**NOTICE OF ADDENDUM
ADDENDUM NO. 5**

**CONTRACT NO. 7939
MADISON MUNICIPAL BUILDING - RENOVATION**

Date: 4/24/2017
Project Name: **Madison Municipal Building Refurbishment**
Project No: 2014057.00
Project Phase: Bid
Project Location: Madison, WI

ADDENDUM No. 5

M101

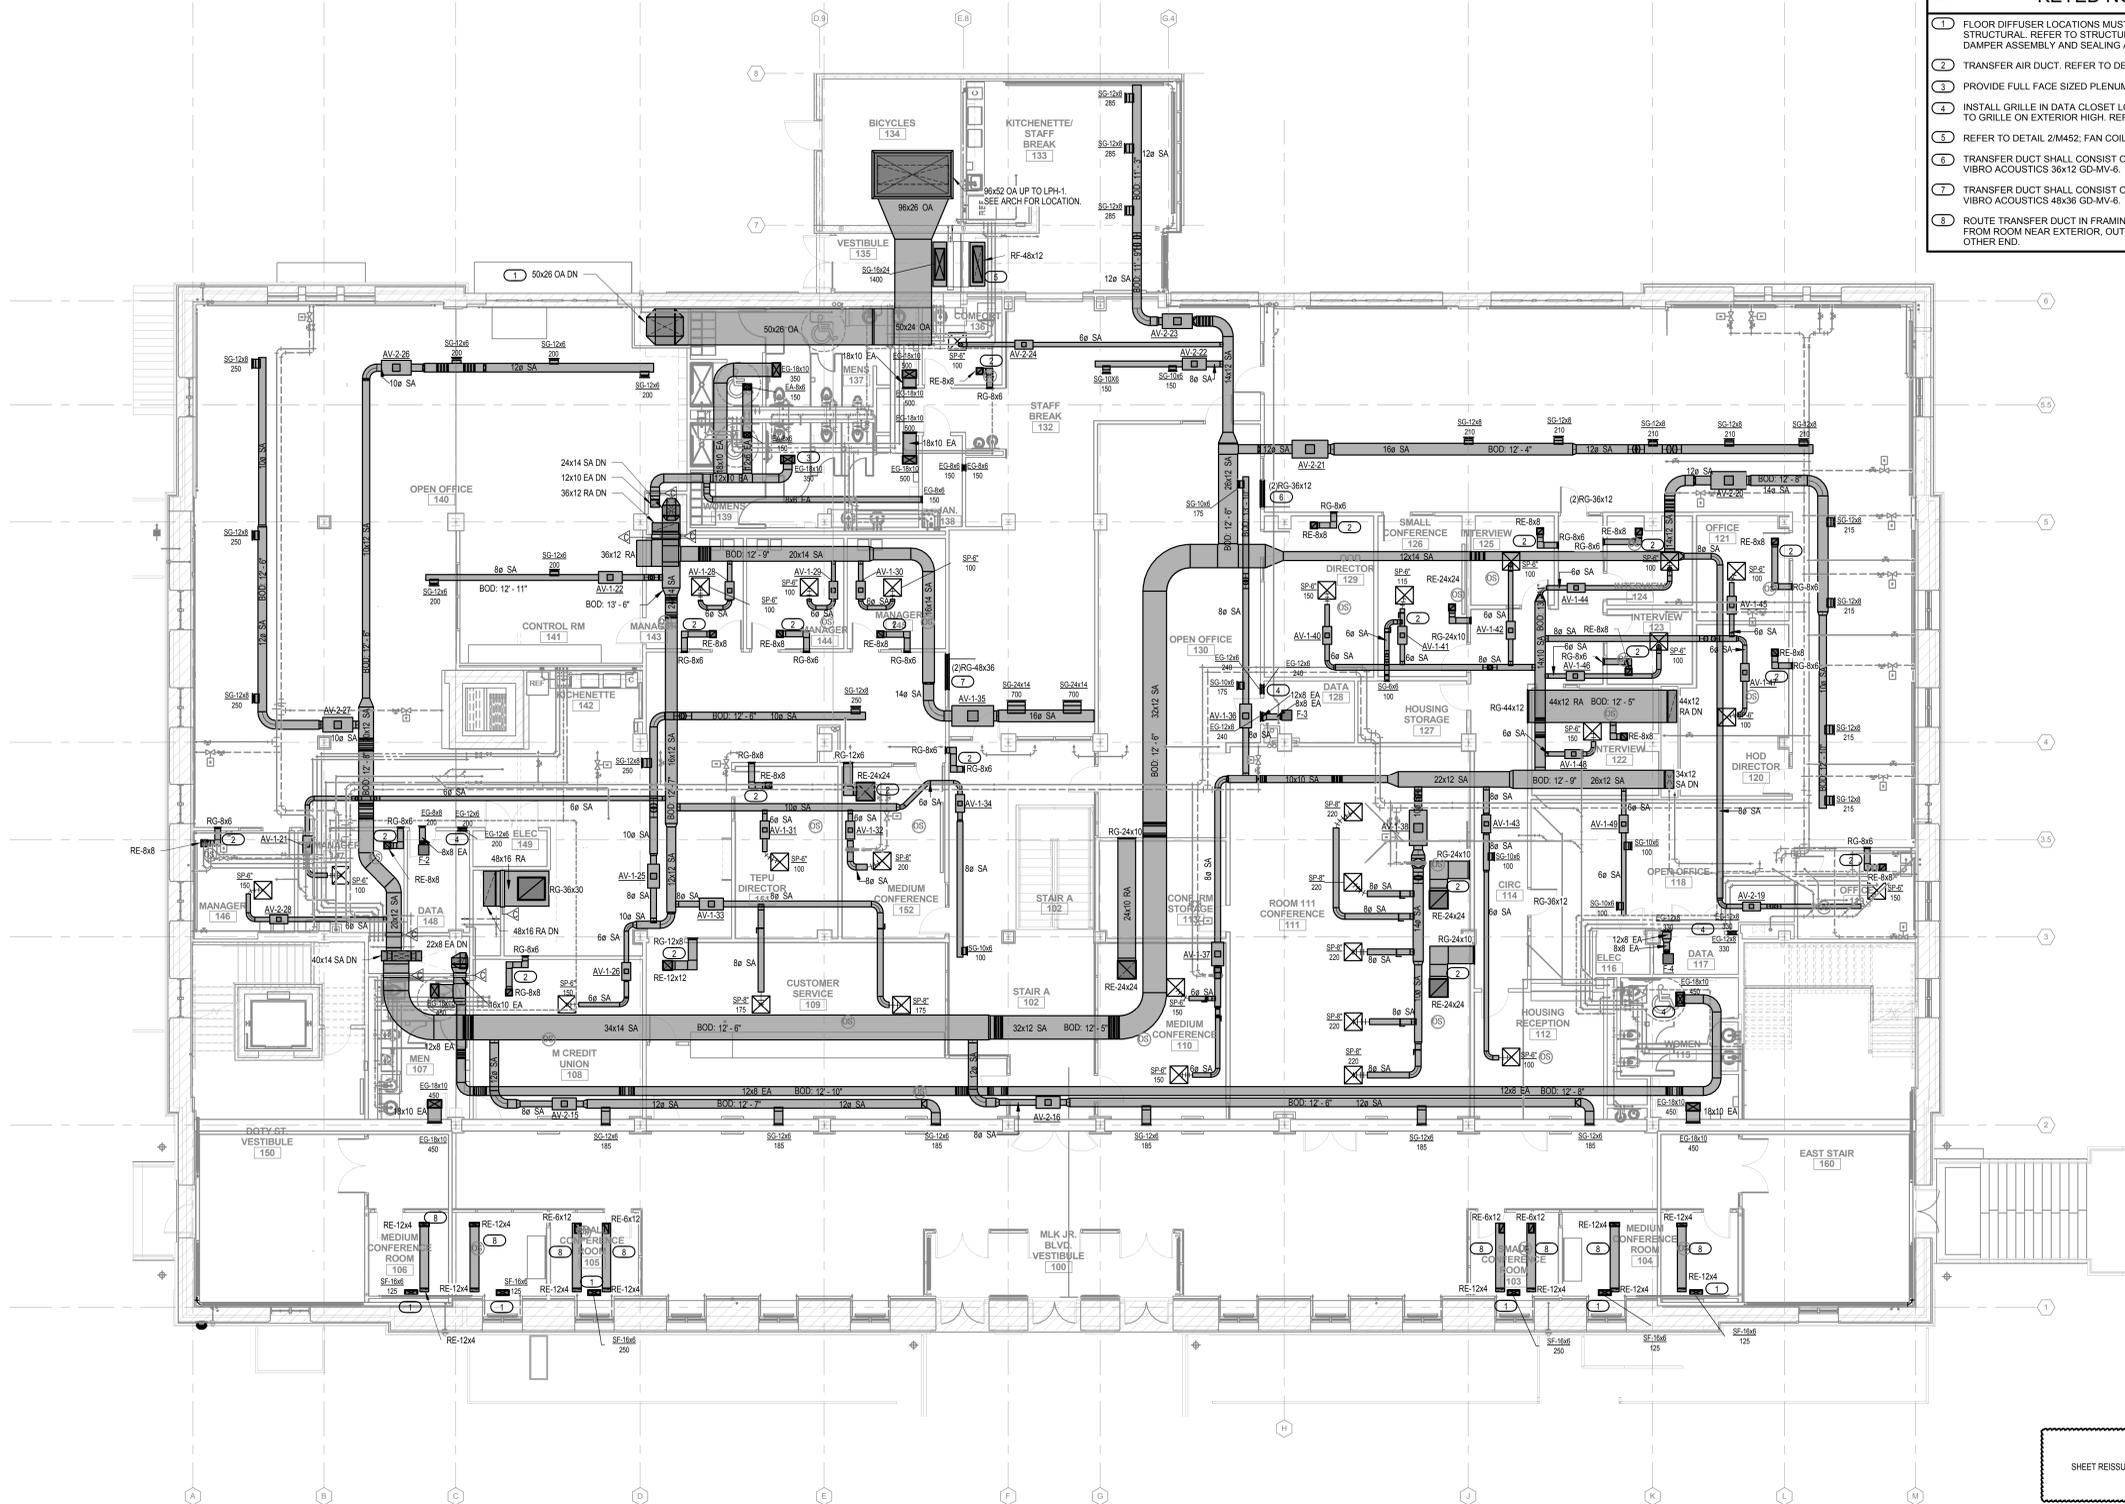
SHEET REISSUED WITH DUCT SIZES SHOWN.

EXHIBIT I M102

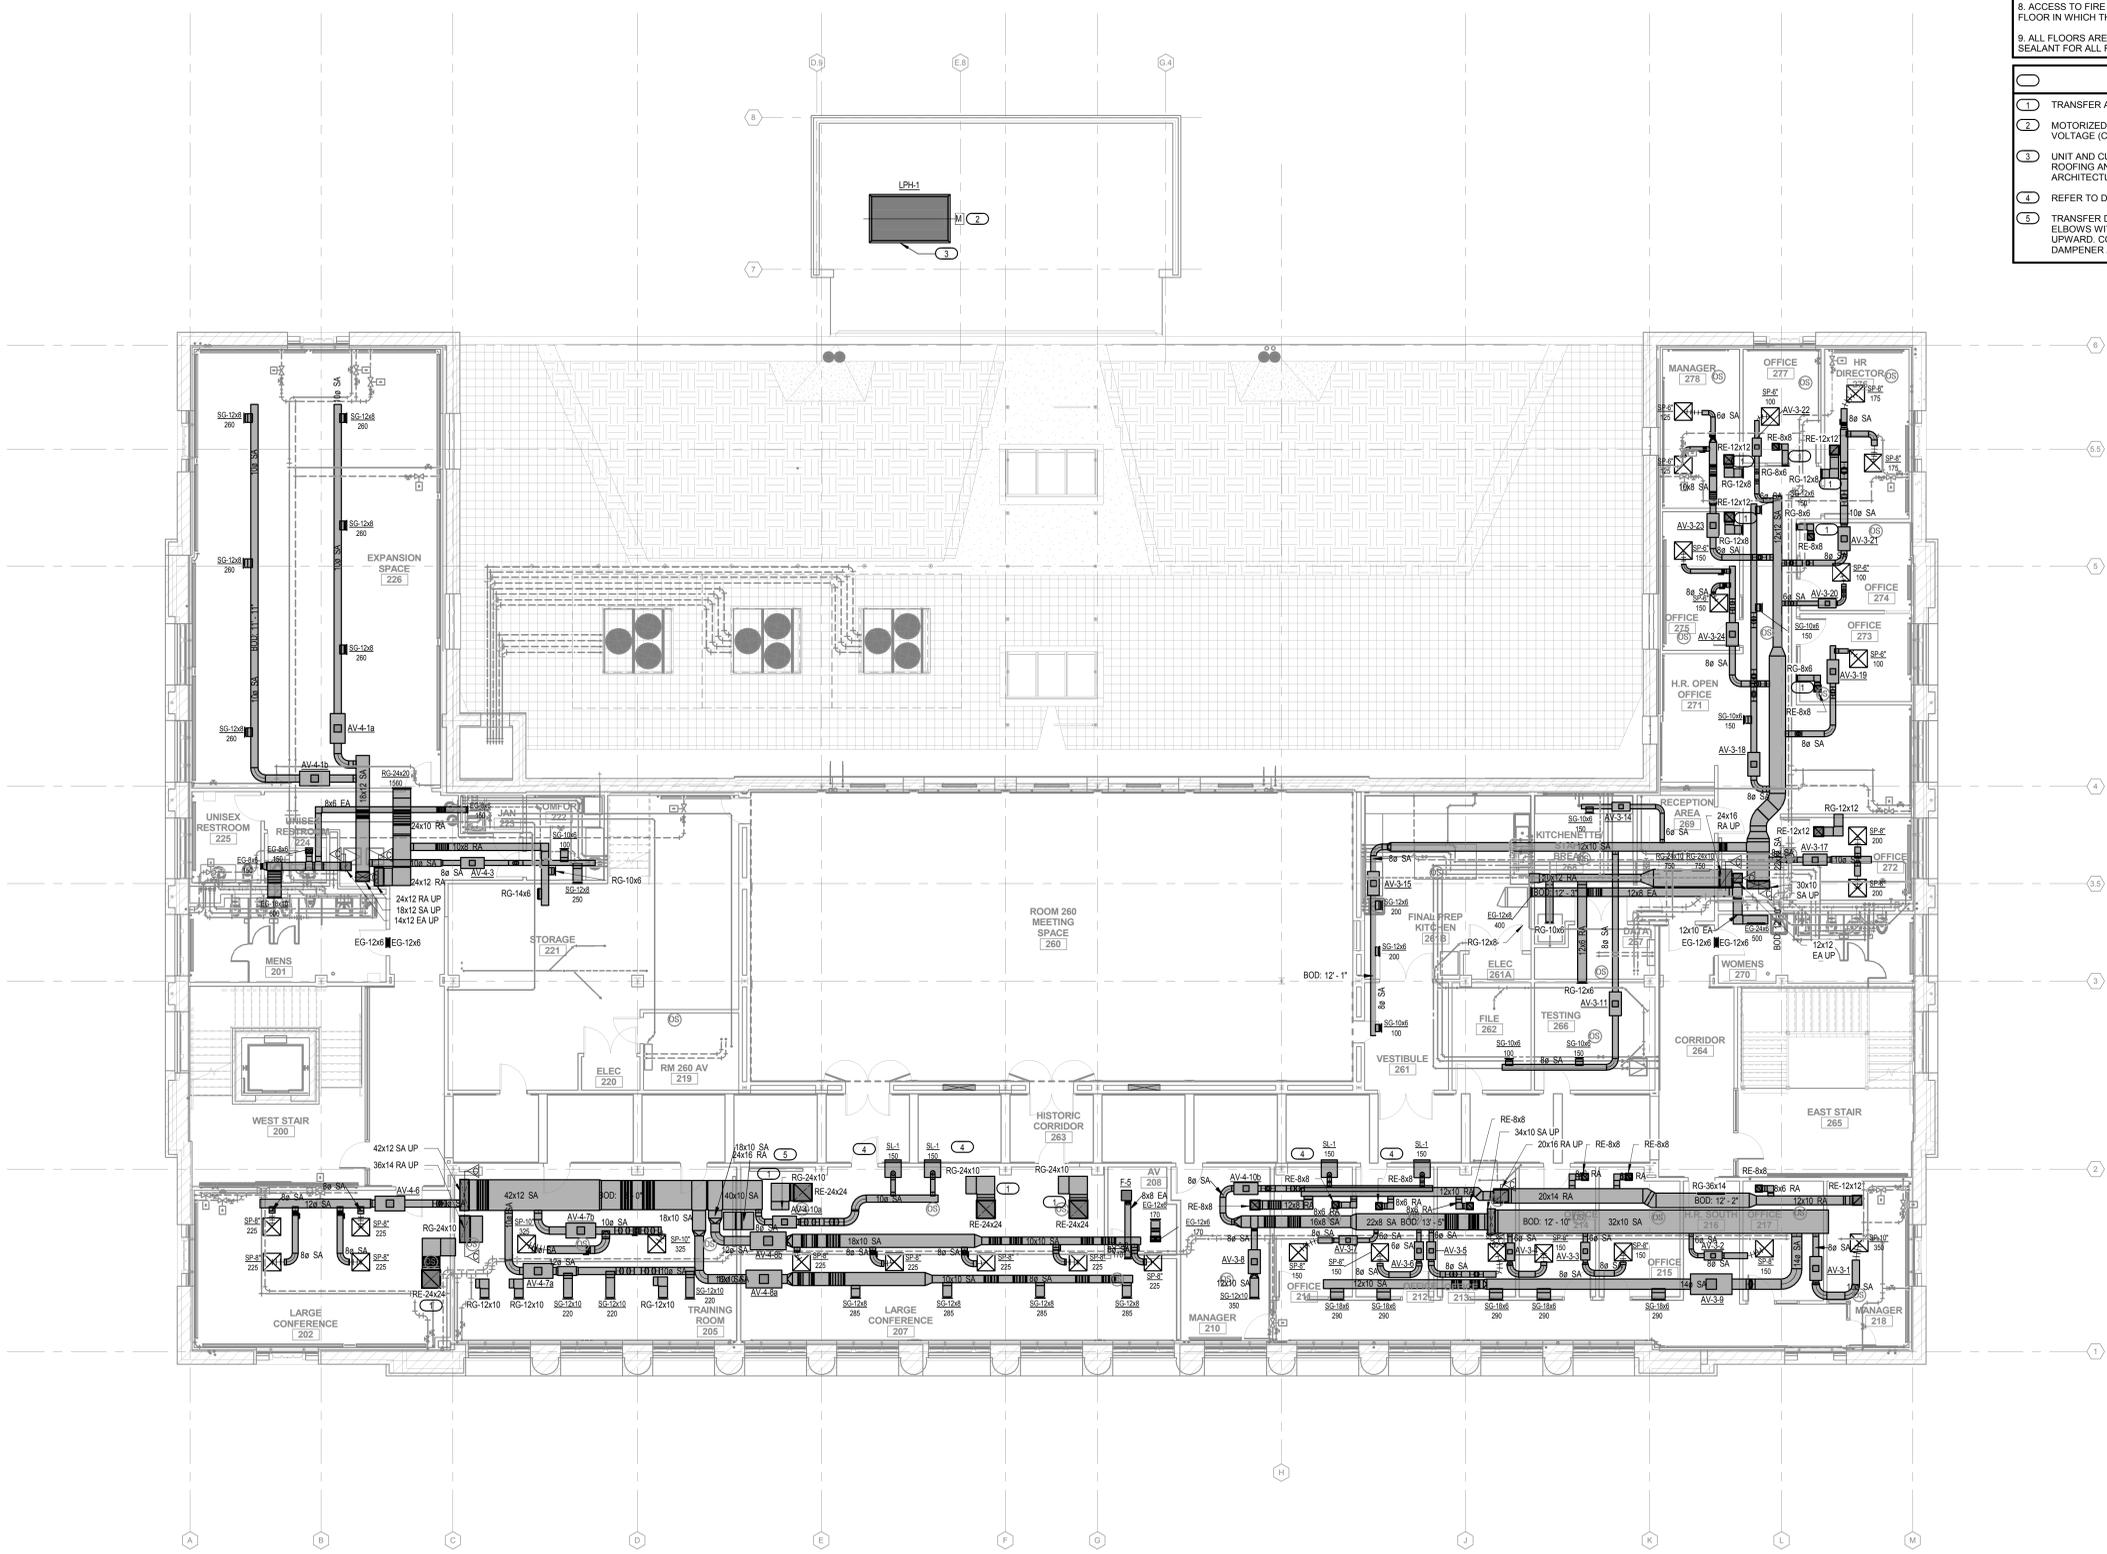
SHEET REISSUED WITH DUCT SIZES SHOWN.

M421

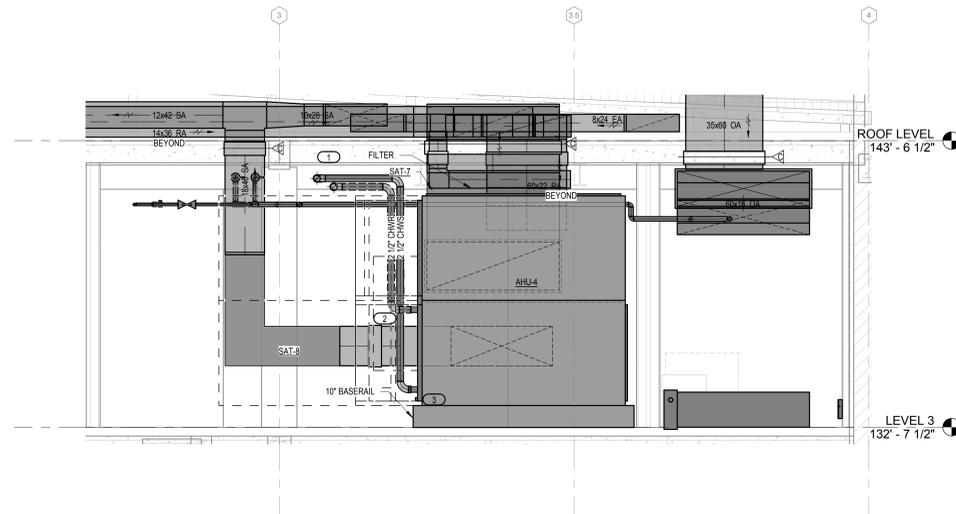
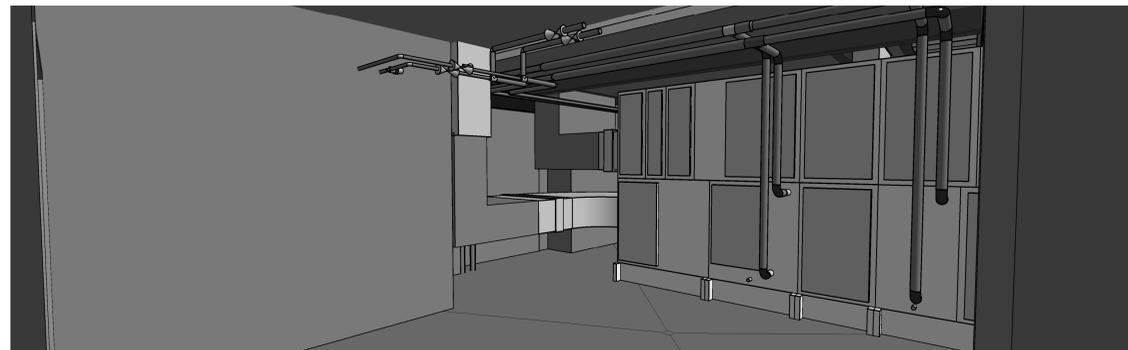
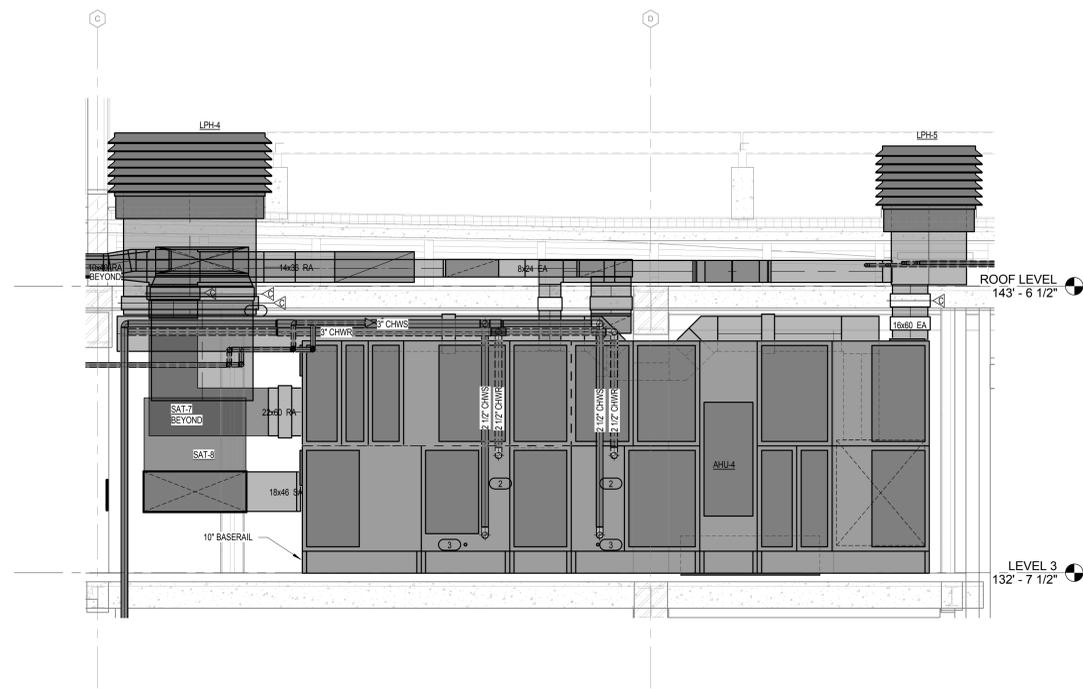
△
SHEET REISSUED WITH DUCT SIZES SHOWN
